Case No. 3:17-CV-01223 (VC)

**STIPULATION AMENDING CONSENT
 AGREEMENT; ~~PROPOSED~~ ORDER
 THEREON**

**(Federal Water Pollution Control Act,
 33 U.S.C. §§ 1251 to 1388)**

EXHIBIT A – 2018 Facility Map

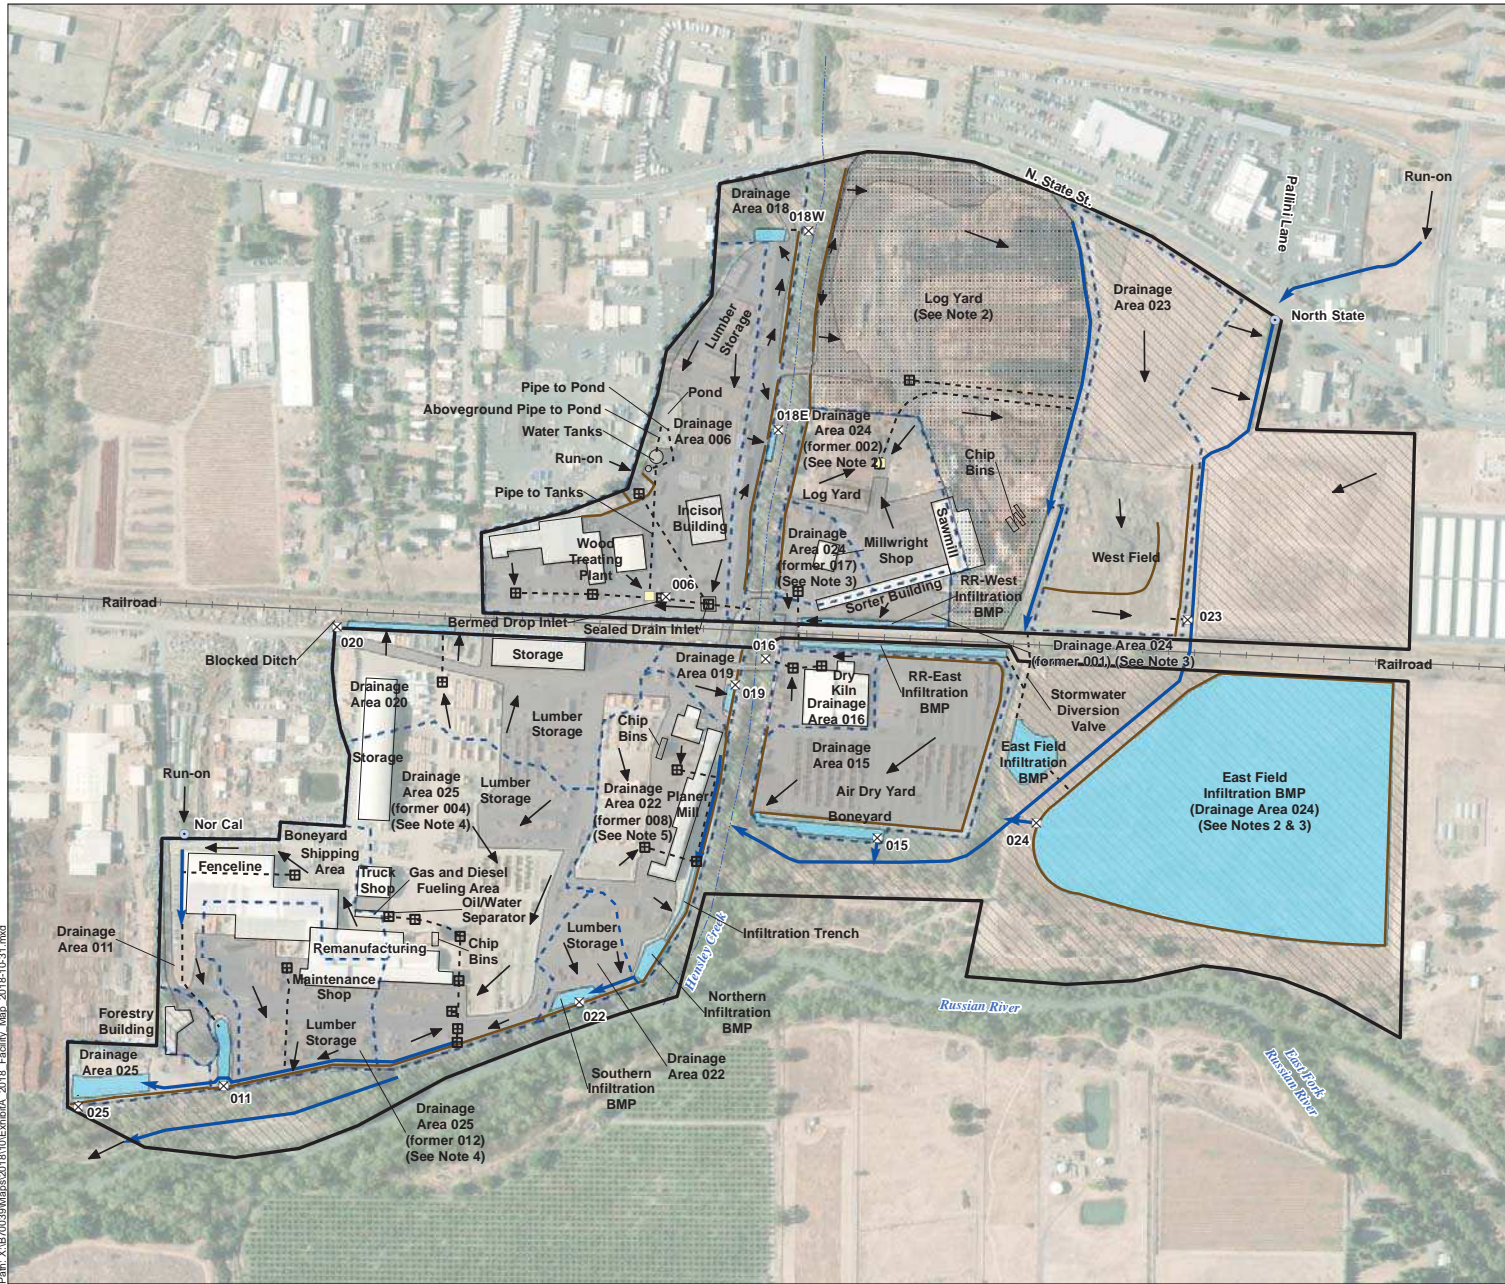
15 (o) *Drainage Areas 008, 019 and 022.* The DPs for 008, 019 and 022 shall remain
16 separate and sampled at their current location for the 2017-2018 Reporting Year. On or
17 before October 1, 2018, MFP shall combine DAs 008 and 022, and all storm water from
18 former DA 008 shall be routed to and sampled at DP 022. Drainage Area 019 shall remain
19 separate and sampled at DP 019.

23 (q) *Construction of New Northern Infiltration BMP in DA 022.* On or before
24 October 1, 2018, MFP shall construct a new infiltration BMP adjacent to the north end of DA
25 022 (formerly DA 008). See **Exhibit A, 2018 Facility Map** for location of the northern
26 infiltration BMP and **Exhibit C, Infiltration BMPs Dimensions Table** for approximate
27 dimensions. MFP shall prepare construction drawings for this infiltration BMP (formerly DA
28

1 008 Infiltration BMP), with a level of detail similar to those as-built drawings prepared under
2 Paragraph I.2(l), above, and provide them to CSPA by June 1, 2018 pursuant to the notice
3 provisions below. The northern infiltration BMP shall connect to an existing infiltration BMP
4 in DA 022 (the southern infiltration BMP), and excess storm water, if any, shall discharge via
5 DP 022. See **Exhibit A, 2018 Facility Map.**

8 (t) *Combination of Drainage Areas 008 and 022.* On or before October 1, 2018,
9 MFP shall combine DAs 008 and 022 as described in Paragraph I.2(o) by connecting the two
10 infiltration BMPs located within these drainage areas. See **Exhibit A, 2018 Facility Map.**

12 (v) *Installation of Berms Along Hensley Creek.* On or before October 1, 2018,
13 MFP shall add berms along Hensley Creek as needed to direct all sheet flow to the infiltration
14 BMPs discussed in (q) above. See **Exhibit A, 2018 Facility Map.**

15 (w) *Reestablishment of Discharge Point 022.* On or before October 1, 2018, MFP
16 shall relocate and reestablish DP 022 at the existing infiltration BMP in DA 022 (the southern
17 infiltration BMP described in item (q) above) and reconfigure berms as necessary to direct
18 sheet flow to the infiltration BMP. See **Exhibit A, 2018 Facility Map.**

22 (ee) *Combination of Drainage Areas 001 and 017.* On or before October 1, 2018,
23 MFP shall regrade as needed to combine DAs 001 and 017. MFP shall route storm water
24 from existing DAs 001 and 017 under the railroad to the new DA 024 RR-East Infiltration
25 BMP. See **Exhibit A, 2018 Facility Map.**

26 (ff) *Construction of Drainage Area 024 RR-East Infiltration BMP.* On or before
27 October 1, 2018, MFP shall construct a new infiltration BMP located between the railroad
28

tracks and DAs 015 and 016.

(gg) *Rerouting of Storm water Flows from DAs 001 and 017.* On or before October 1, 2018, MFP shall reroute drainage from the new DA 024 RR-East Infiltration BMP to the East Field Infiltration BMP for further infiltration and ultimate discharge at DP 024. When this reconfiguration is complete, DAs 001 and 017 will become part of DA 024. See **Exhibit A, 2018 Facility Map** for the locations and **Exhibit C, Infiltration BMPs Dimensions Table** for the approximate dimensions of these BMPs.

5. **Exhibit A, 2018 Facility Site Map; Exhibit C, Infiltration BMPs Dimensions Table**, and **Exhibit H, Sampling Parameters** of the Consent Agreement are replaced by the attached **Exhibits A, C and H** of the same titles; each replacement exhibit has been updated for consistency with the changes described herein.

3. Stormwater from Drainage Areas 017 and 001 will be diverted to the RR-East infiltration BMP and then on to the East Field for further infiltration and ultimately discharge at Discharge Point 024. When this reconfiguration is complete, Drainage Areas 017 and 001 will become part of Drainage Area 024.

4. Stormwater from Drainage Areas 004 and 012 will be diverted to an infiltration BMP in Drainage Area 025 and ultimately discharge at Discharge Point 025. When this reconfiguration is complete, Drainage Areas 004 and 012 will become part of Drainage Area 025.

5. Stormwater from the Drainage Area 008 infiltration BMP ("northern infiltration BMP") will be routed through the existing Drainage Area 022 BMP ("southern infiltration BMP") and ultimately discharge at Discharge Point 022. When this reconfiguration is complete, Drainage Area 008 will become part of Drainage Area 022.
